# New M240B Charging Handle Requires Adapter

HERE'S WHAT YOU'LL NEED TO USE WITH CROWS FOR THE NEW M240B MACHINE GUN CHARGING HANDLE.

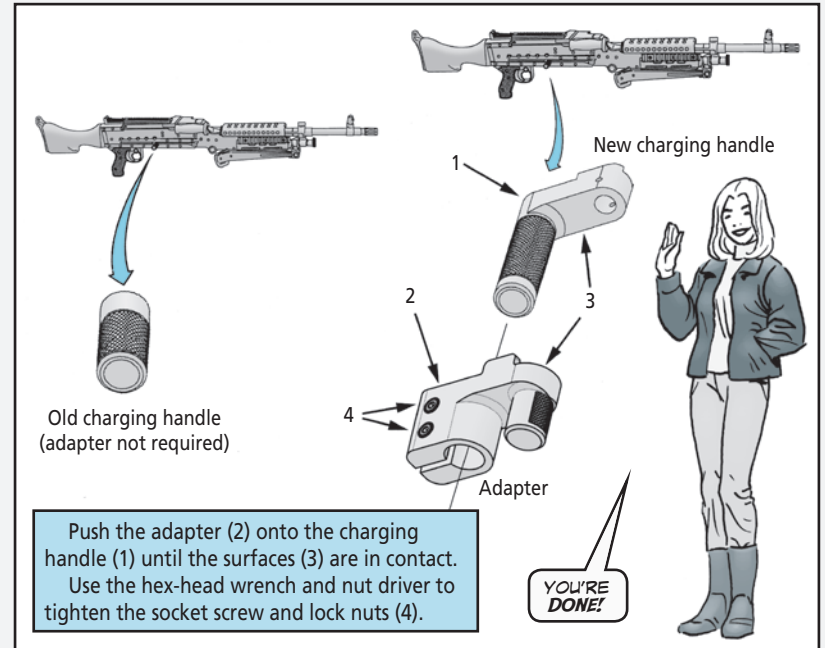
Some of the M240B machine guns used on the M153 CROWS II (common remotely operated weapons station) have a new charging handle. But to use the new charging handle with CROWS II requires an adapter.

Weapons configured with the older charging handle can be used with CROWS II without the adapter. Look at the picture on Page 39 to see which charging handle your M240B uses.

SOME OF THE FIRST ADAPTERS SENT TO THE FIELD HAD THE WRONG SAE 8-32 ATTACHING SCREWS.

REPLACE THEM WITH THE METRIC HARDWARE THAT COMES WITH THE NUT DRIVER.

To install the adapter, you need a 3mm hex-head wrench and a 7mm nut driver. The hex-head wrench is part of the CROWS II operator's tool kit.

The nut driver is being added to the tool kit. You can get a nut driver and the two attaching screws and lock nuts from your local CROWS II new equipment training team (NET) representative, the local CROWS II support group (CROWS Nest), your TACOM LAR or by ordering:

- **Nut driver,**  
NSN 5120-01-278-6697
- **2 screws, hex-head socket,**  
NSN 5305-01-577-9519
- **2 nuts, self-locking,**  
NSN 5310-01-577-9651
